STAFF REPORT
COMMUNITY DEVELOPMENT DEPARTMENT

HEARING DATE: October 22, 2020
 Continued from: August 6, September 3 and 17, 2020

SUBJECT: H-2020-0064
 Pura Vida Ridge Ranch

C. Landscape Plan for Subdivision (date: 4/30/2020)

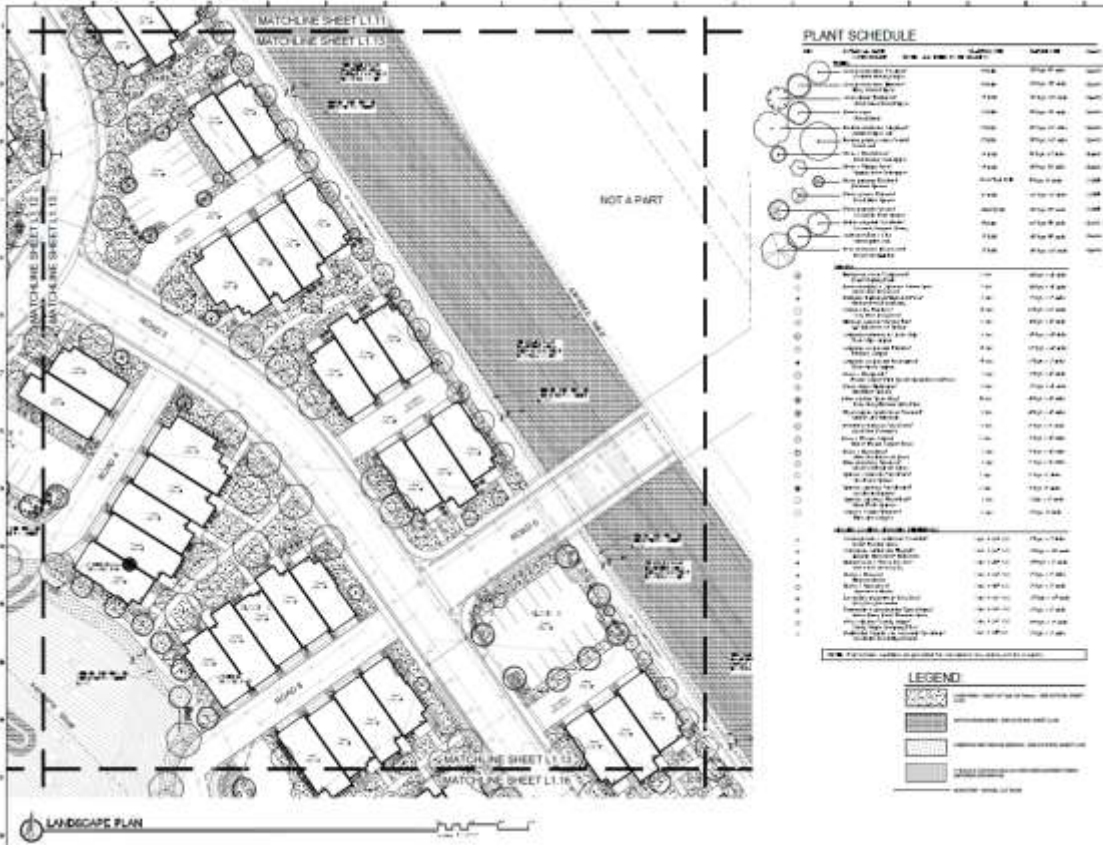
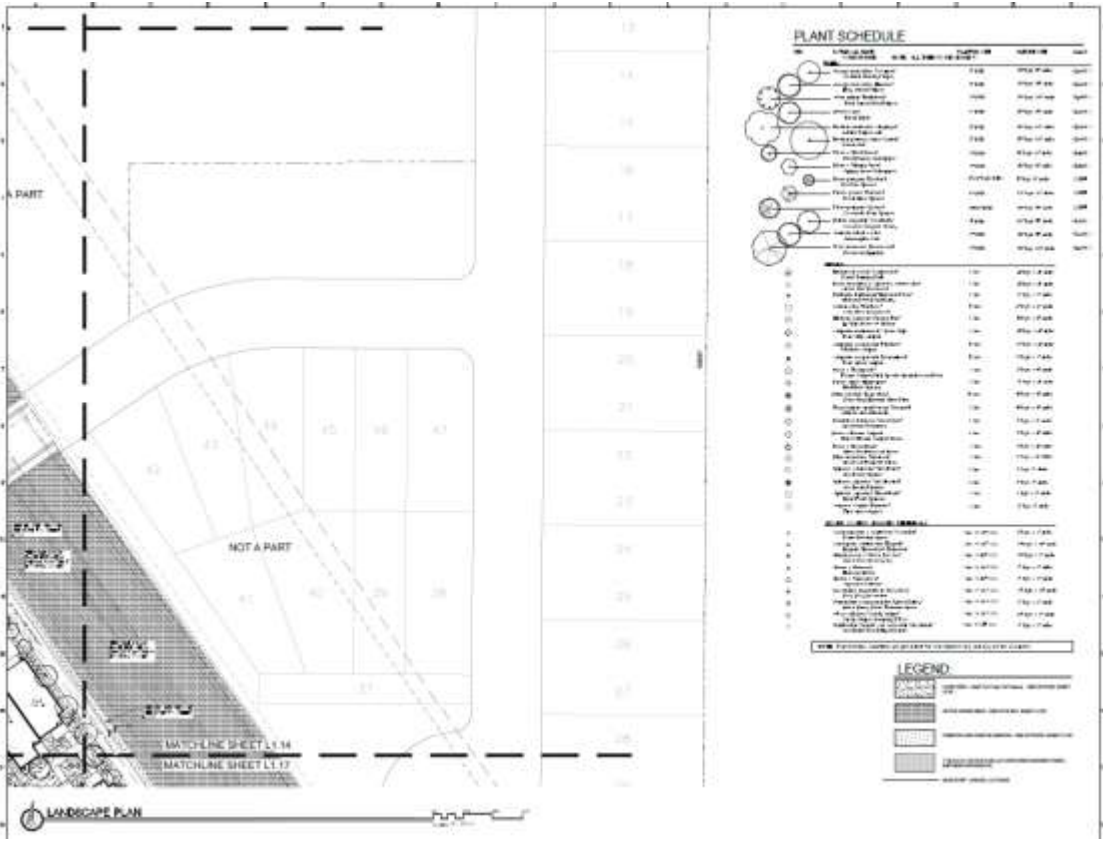
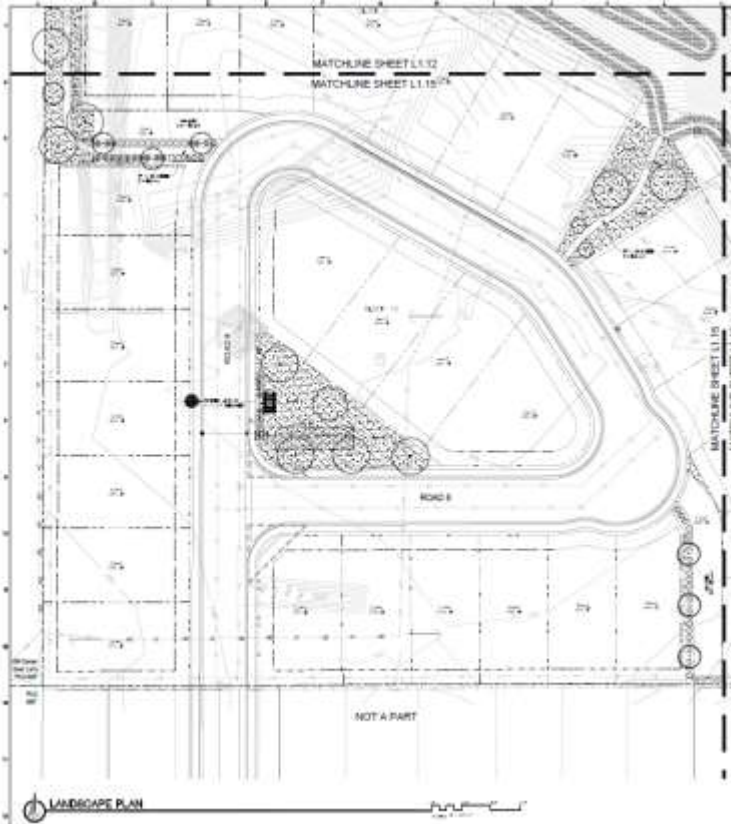
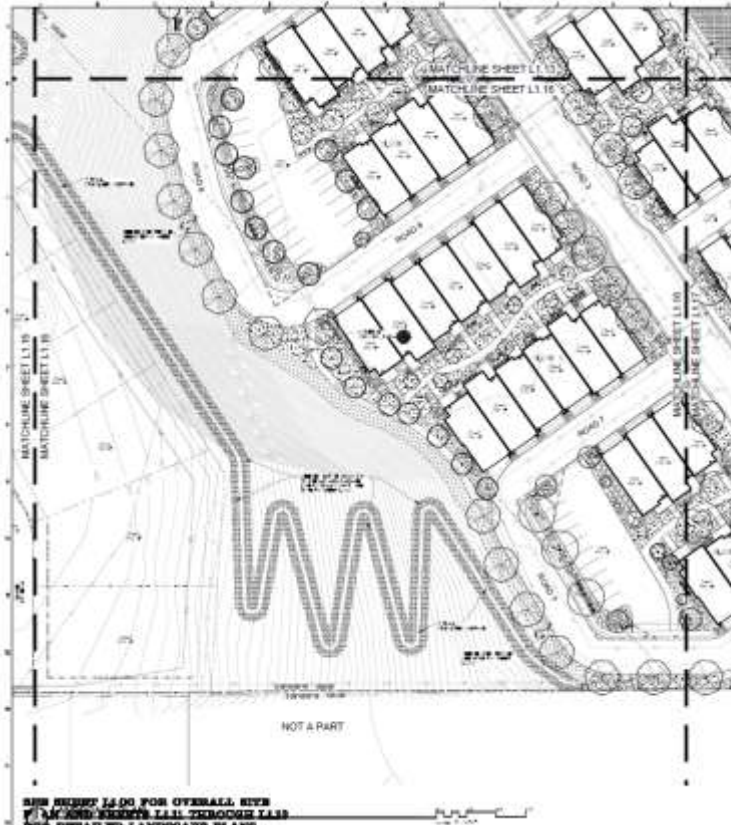
A 35-foot wide street buffer is required along E. Lake Hazel Rd., an arterial street and entryway corridor, per UDC Table 11-2A-7, landscaped per the standards listed in UDC 11-3B-7C as proposed. A berm and an additional 10 trees are proposed above the minimum requirement. **Bushes should be added within the buffer in accord with UDC 11-3B-7C.3, which requires a combination of trees and shrubs along with lawn or other vegetative groundcover.**

Staff and the Fire Dept. is very concerned about the potential danger of wildfires in this area. Therefore, the Fire Dept. is requiring defensible space to be provided – a minimum of 30’ (and possibly more for steep topography) from all structures to the undeveloped, natural open space – plantings within this area should be fire-resistant (see Section IX.C for more information). A wildfire safety plan is required to be approved by the Fire Dept. prior to approval of the first final plat. A copy of the approved plan should be included in the CC&R’s for the subdivision.

All fencing is required to comply with the standards listed in UDC 11-3A-7. No fencing is proposed on the landscape plan. **The Developer is required to construct fencing abutting pathways and common open space lots to distinguish common from private areas per the standards listed in UDC 11-3A-7A.7. Fencing in accord with this standard should be depicted on a revised landscape plan.**

2. The preliminary plat included in Section VIII.B, dated August 24, 2020, is approved as submitted.
3. The landscape plan included in Section VIII.C, dated April 30, 2020, shall be revised as follows:

- a. Depict bushes within the buffer along E. Lake Hazel Rd. in accord with UDC 11-3B-7C.3.
 - b. Depict fencing abutting pathways and common open space lots to distinguish common from private areas per the standards listed in UDC 11-3A-7A.7; include a detail of the proposed fence.

- c. Depict a minimum 30-foot wide (may be increased to account for steep topography) defensible space extending out from any part of adjacent structures to the hillside in accord with Fire Dept. comments in Section IX.C. Hazardous and fire-prone vegetation shall be prohibited in this area and only fire resistant plants should be utilized for landscaping in this area.

F. Parking Exhibit

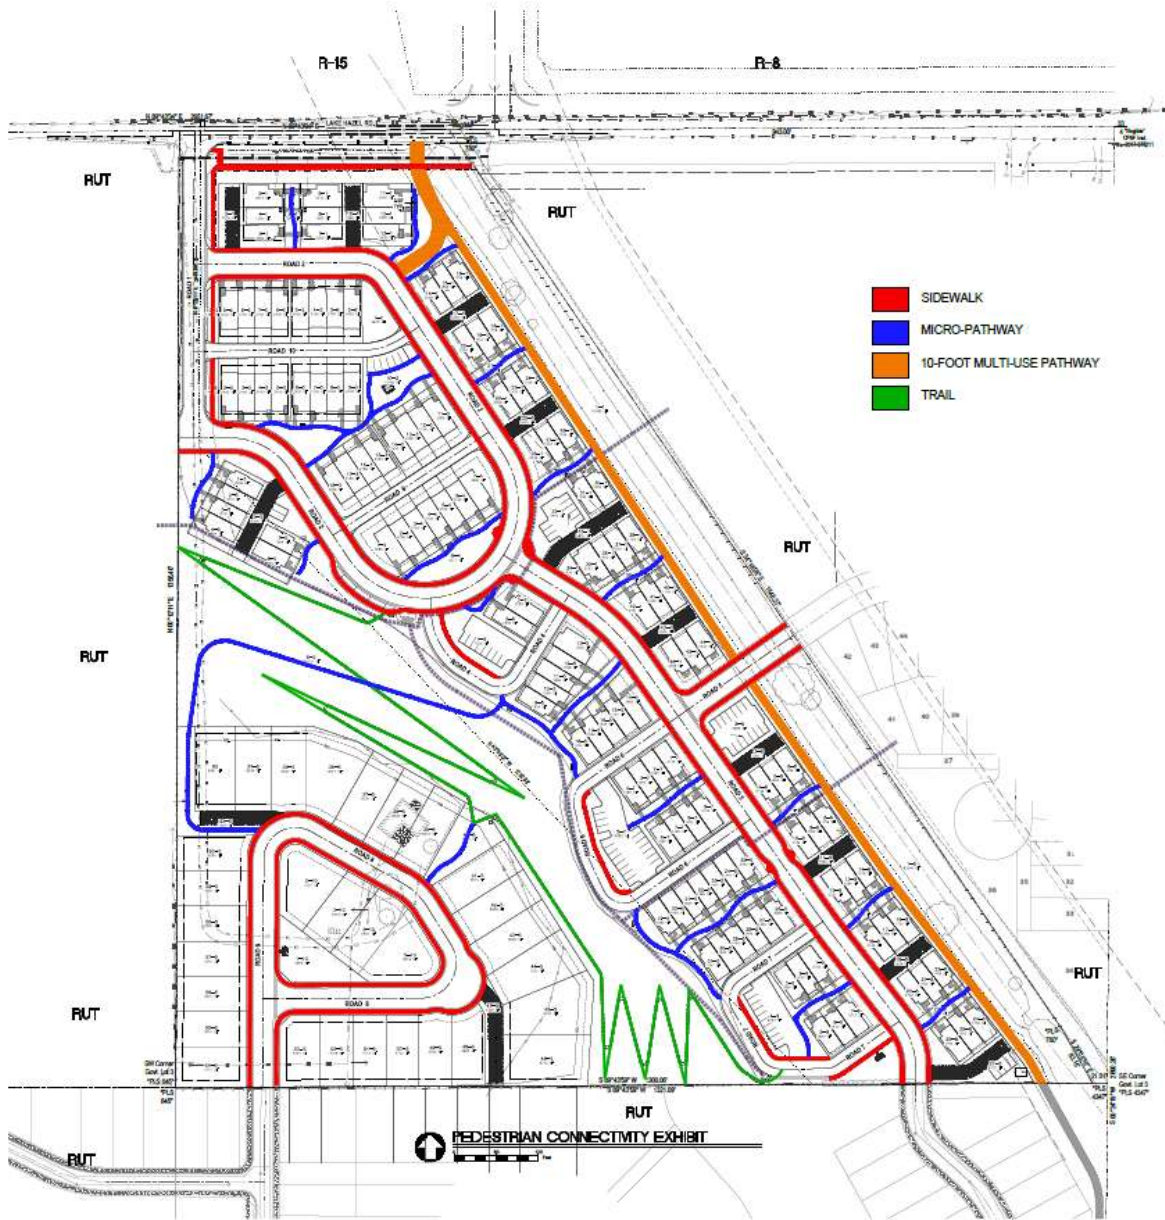
The Applicant is proposing 20’ long x 18’ wide parking pads, which are 2’ less in width than required. The parking pads should be revised to be 20’ x 20’ in accord with UDC Table 11-3C-6.

16. The parking pads for individual lots shall be revised to be 20' x 20' in accord with UDC Table 11-3C-6.
17. An exception was approved to UDC 11-3A-17D, which requires sidewalks to be constructed on both sides of all public streets, to only require sidewalks along the east sides of the 24' wide street sections (i.e. Roads 4, 6 and 7) adjacent to the parking areas as depicted on the Pedestrian Connectivity Plan in Section VIII.G *and* as required by ACHD (i.e. extend the sidewalks on the east sides of Roads 4 and 6 along the entire common lot/parking area).
